# Access Compliance Report Public Rights-of-Way (Curb Ramps)

Main Street: **SECOND\_ST** Cross Street: **N/A** Location: **N**

ADA ID: **RPRK211026180141** Ramp Type: **Type 4 - Parallel** Initial Pass/Fail: **Fail** Overall Compliance: **No** Severity Score: **2**

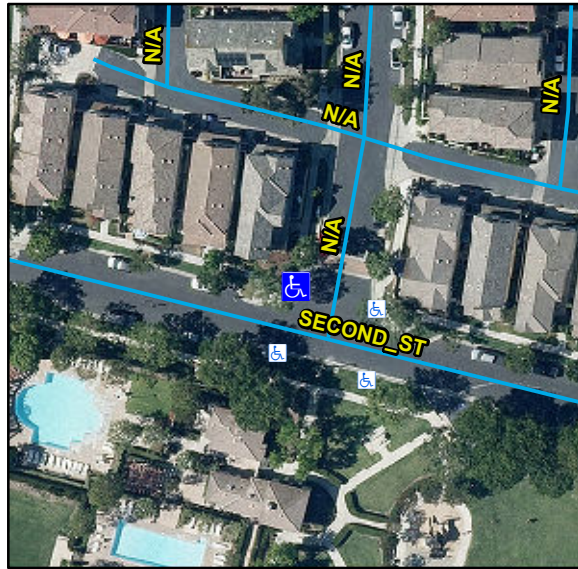
| Compliance | Description                   | Data              | Compliance | Description                   | Data       |
|------------|-------------------------------|-------------------|------------|-------------------------------|------------|
| <b>No</b>  | Ramp Cross Slope LT (%)       | <b>2.9</b>        | <b>No</b>  | Ramp Cross Slope RT (%)       | <b>3.2</b> |

**Remove & Replace Curb Ramp With Two New Directional Ramps or Equivalent.**
